LATE REPRESENTATIONS SCHEDULE
PLANNING COMMITTEE – 22ND JULY 2015

PAGE NO. 1	APPLICATION NO. 13/00944/DCO
ADDRESS:	16, THE AVENUE, LLANDAFF
FROM:	Applicant's agent.
SUMMARY:	<p>The development proposal retains the TPO Magnolia Tree, and the parking layout has been amended accordingly.</p> <p>The Arboricultural Impact Assessment indicates that the tree suffers from significant structural defects which require remediation through pruning to prevent failure. Pruning works would need to be undertaken to improve the safety and health of the tree irrespective of this development. The development includes a proposal to implement remedial pruning works, which could be conditioned by any planning permission, and which would improve the safety and health of the tree as well as maintaining a contribution to public amenity.</p> <p>The Magnolia tree will be physically protected during the construction works in strict accordance with BS5837:2012 Trees in Relation to Design, Demolition and Construction.</p> <p>The proposed development fully complies with all relevant National and Local Planning policies, and with the Council's SPG "Trees and Development".</p> <p>A set of drawings showing the ret

description:
proposed landscaping plan

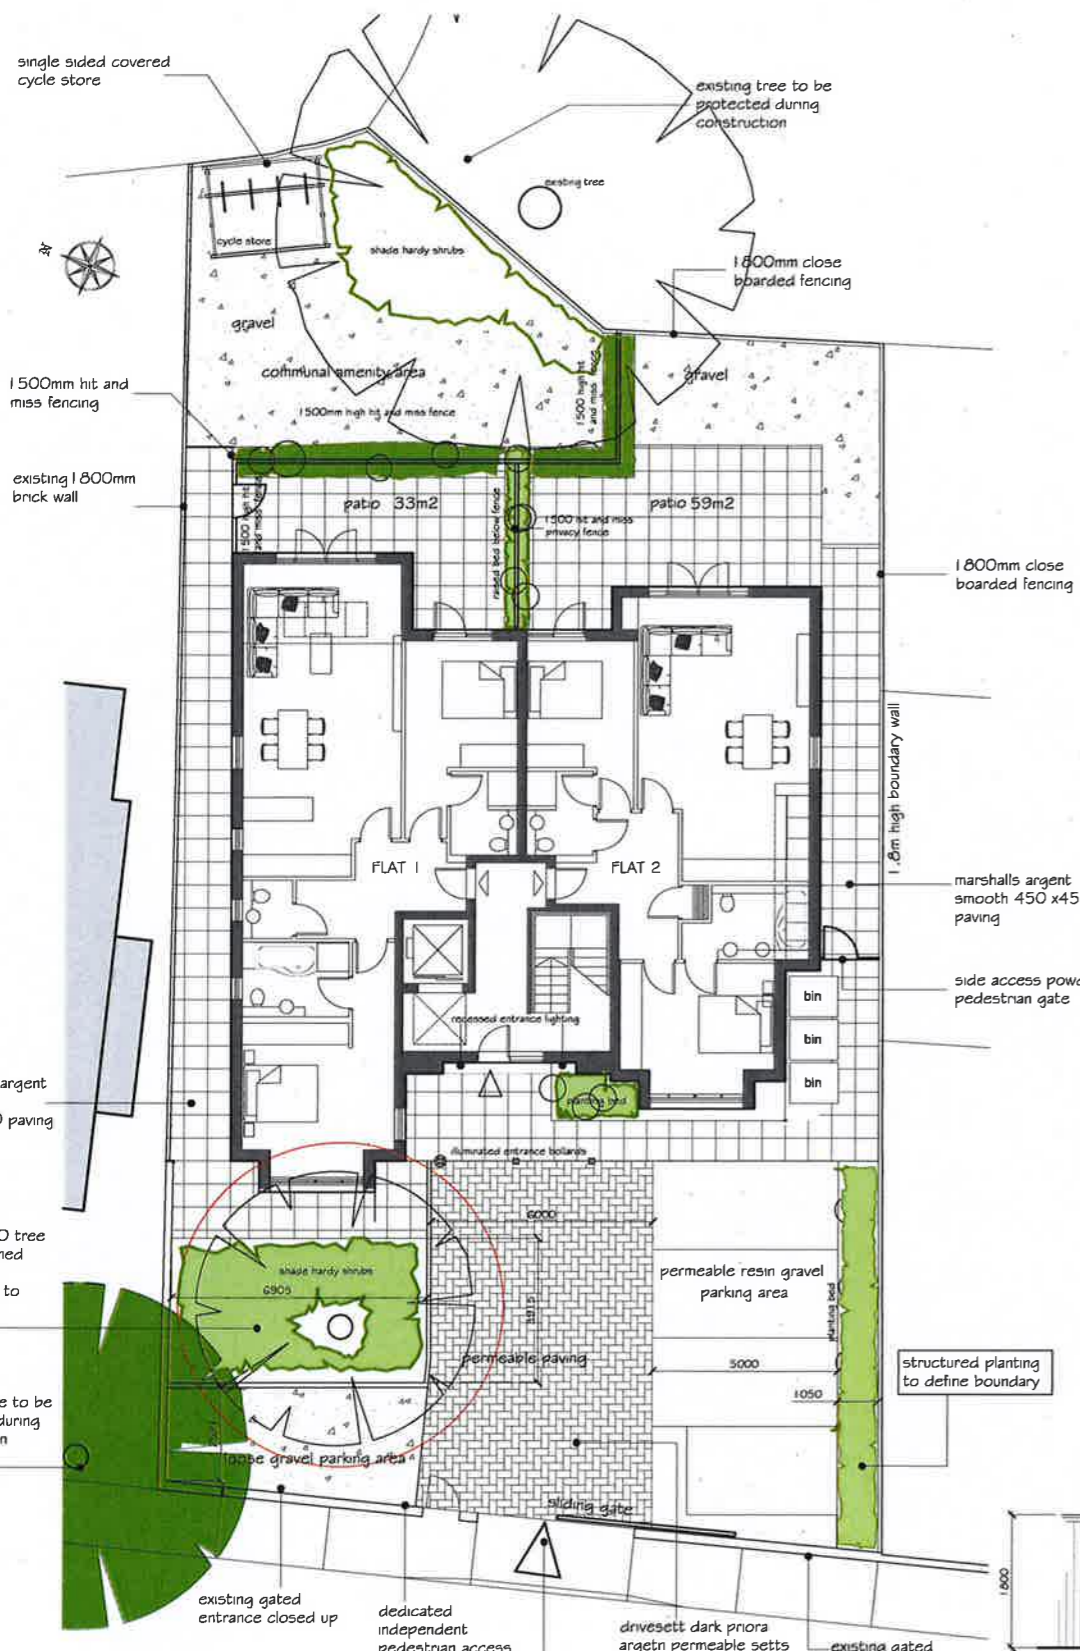
REMARKS:	<p>The proposed retention of the <i>Magnolia</i> is supported. It will suffer incursions into its nominal Root Protection Area (RPA) by the proposed building footprint, paving, a loose gravel parking area and new soft landscaping comprising shade hardy shrubs. Whilst it is not clearly annotated there is a strong possibility that a new sewer pipe will incur into the RPA. A wall, fence or other edging feature is shown within the RPA following the north-eastern edge of the proposed drive before heading north-west away from the drive to join the boundary with the house to the north. Construction of this feature may result in harm to or loss of roots. It should also be noted that micro-drainage is not shown on the submitted plan but may be required and may incur into the RPA.</p> <p>Since no Tree Constraints Plan has been submitted based on an existing topographic plan, accurate assessment of the likely impact of the proposed incursions into the RPA as compared with the rooting conditions currently enjoyed by</p>

the *Magnolia*, is hindered. However, it is clear that there will be a substantial incursion (estimated to be in excess of 20%) by engineered features (paving and building footprint) into the RPA. Taken alone the incursion by the building footprint is minimal, and whilst it should preferably be designed out, the incursion might be acceptable subject to improvements to the RPA elsewhere. Unfortunately, evidence to demonstrate positive changes in the RPA is lacking. Unless the construction of the paved patio and permeable paved drive is specified in such a way that the likely impact on the health of the tree will be neutral or positive – i.e. that there will be no phytotoxic materials used in construction and no compaction or impediment to the percolation of water and diffusion of gases within the RPA (but preferably that there will be improved percolation of water and gaseous diffusion), then it must be assumed that their construction will result in unacceptable harm. Similarly, whilst it is understood based on the submitted Treescene Ltd Arboricultural Impact Assessment dated 14th October 2014 that the ‘tree is sited within a permeable, hard stand area that has historically been utilised as a driveway and parking area for vehicles’, this does not mean that the proposed loose gravel parking space will not have the potential to cause harm to roots. The most serious form of harm possible is direct crushing of roots and their asphyxiation due to compaction caused by trafficking. A thin layer of gravel is not sufficient to protect soil from compaction. Any car-parking within the RPA should be designed to allow for unimpeded water percolation and gaseous diffusion – an improvement in permeability and aeration beneath the proposed car-parking space would help to offset the incursions by the building footprint and the other potentially detrimental incursions into the RPA cited above.

Careful precautions taken in the construction of the drive, patio and parking area could be pointless if new service connections are required within the RPA of the *Magnolia*, or if a wall is built in the heart of its RPA. Clarification is needed concerning the location of all proposed services including any micro-drainage and the nature of the ‘edging’ features shown and described above.

The proposed soft landscaping within the RPA of the *Magnolia* could result in beneficial or detrimental impacts to roots dependent on how it is installed. If machine cultivation is undertaken, levels are changed significantly by importing topsoil and installing it onto compacted sub-soil, or deep planting pits are excavated for new shrubs, then significant and unacceptable harm is likely. However, if the planting

incorporates measures to actively improve the soil environment for *Magnolia* roots – i.e. hand cultivation and other measures to de-compact any compacted soil and incorporate organic matter, and shrubs are planted at small size, in small, carefully positioned pits, then the impact is likely to be neutral or beneficial. Measures that *benefit* the rooting environment of the *Magnolia* would help to offset harm caused elsewhere within the RPA.

Whilst the submitted landscaping details make nominal provision for the planting of light standard *Ginkgo biloba* 'Mayfield', no trees are actually shown annotated on the plan and the space available for new tree planting is negligible. A thin soft strip bounds parking spaces on 'The Avenue' frontage. Whilst this strip could nominally accommodate a small number of light standard 'Mayfield', it is not clear how the trees will have access to the 15m³ of soil specified in the outline planting specification, except perhaps assuming that roots develop in an extremely constrained linear pit for the length of the strip. If this was the case the trees are likely to be vulnerable to structural failure as they mature. In addition, unless they are provided and maintained with a clear stem, conflict is likely between low branches and vehicles. Consequently the plans should be amended to provide for a wider strip and with root available soil volume extending beneath car-parking via structural soil and/or soil crates, with additional aeration and irrigation points provided at distance. In terms of soil, a full topsoil and subsoil specification should be provided.

description:
existing and proposed plans
block plan and site location plan

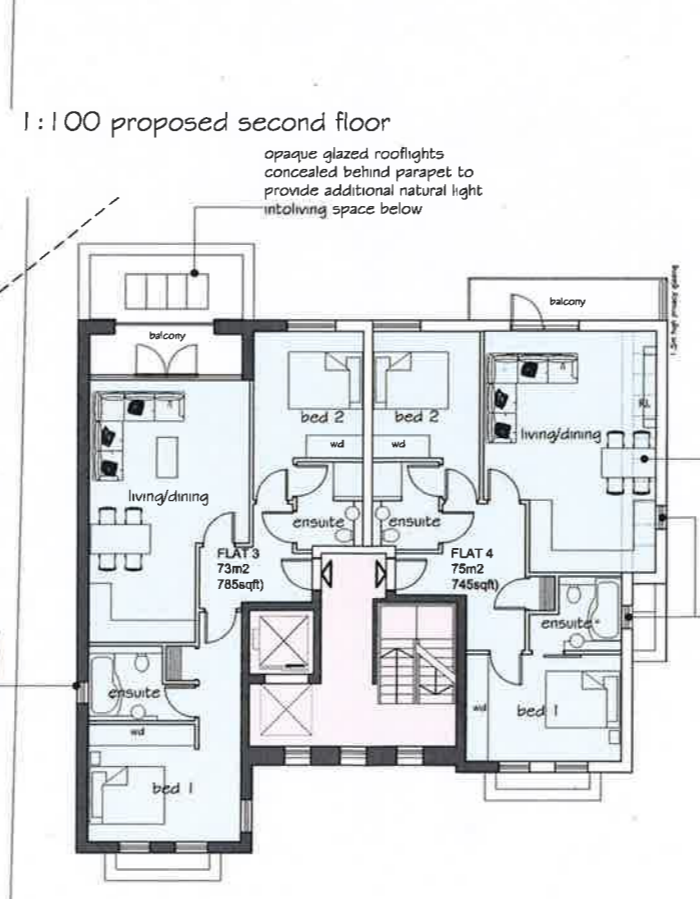
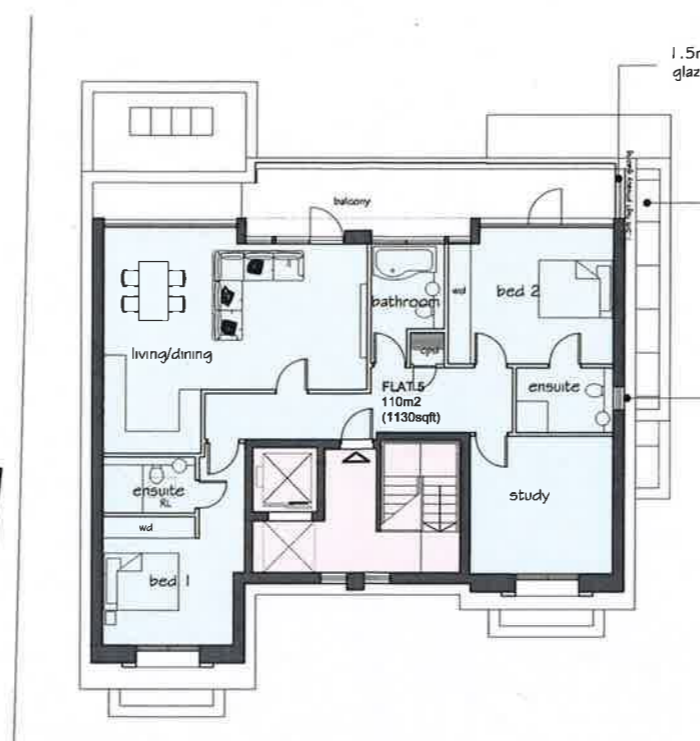
The Treescene Ltd report does not consider the TPO sycamore at the rear of the site, but as with the *Magnolia* the proposed building footprint will incur into its RPA, as does a large area of patio paving, fencing, a cycle store and an area of gravel. As with the *Magnolia* the slight incursion made by the building footprint might be offset by improvements to the RPA elsewhere. Unfortunately without evidence to the contrary it must be assumed that the impact of paving construction and cycle store construction would be harmful or neutral at best. Gravel is nominally permeable

unless it is laid over an impermeable membrane which is quite possible. The construction of fencing will have a negligible impact except where posts are installed into concrete. Hedging would therefore be a preferred treatment.

Aside from the incursions into the RPA of the sycamore, concern remains that the tree will be perceived as a nuisance. A large part of the garden will be directly overhung by the canopy, and future growth is likely to incur over patio areas. Sycamore leaves are large and dark green and a mature tree in full leaf can be oppressive where it overhangs gardens. A further concern is the nuisance caused by honeydew resulting from aphid feeding. Sycamores are commonly subject to heavy aphid colonisation and feeding in spring, early summer and autumn. The honeydew they excrete vaporises and covers a wide area around the tree. Since it is sticky it means that hanging washing is a problem, sooty moulds can develop on honeydew covered plants, paving and garden furniture causing black stains and affecting detrimentally the appearance and photosynthetic performance of other plants. When wetted by rain, honeydew covered surfaces can be very slippery. The quality of life for residents would be detrimentally affected by the close proximity of development to the tree.

<p>recommended reason for refusal (5) should be re-worded as follows:</p> <p>(5) It has not been demonstrated that the development would have no adverse impact on the Magnolia Tree at the front of the site which is the subject of a Tree Preservation Order, and the development would also result in pressure from future residents to carry out works to another protected tree at the rear of the site in order to address issues of overshadowing, damage to property and lack of usable outdoor amenity space, to the detriment of the future health and continued survival of the trees and contrary to policy 11 of the Cardiff Local Plan, policy 2.45 of the deposit Cardiff Unitary Development Plan, Cardiff Supplementary Planning Guidance "Trees and Development" (March 2007) , paragraph 3.35 of Cardiff Supplementary Planning Guidance "Infill Sites (2011) and paragraph 5.2.9 of Planning Policy Wales (July 2014).</p>
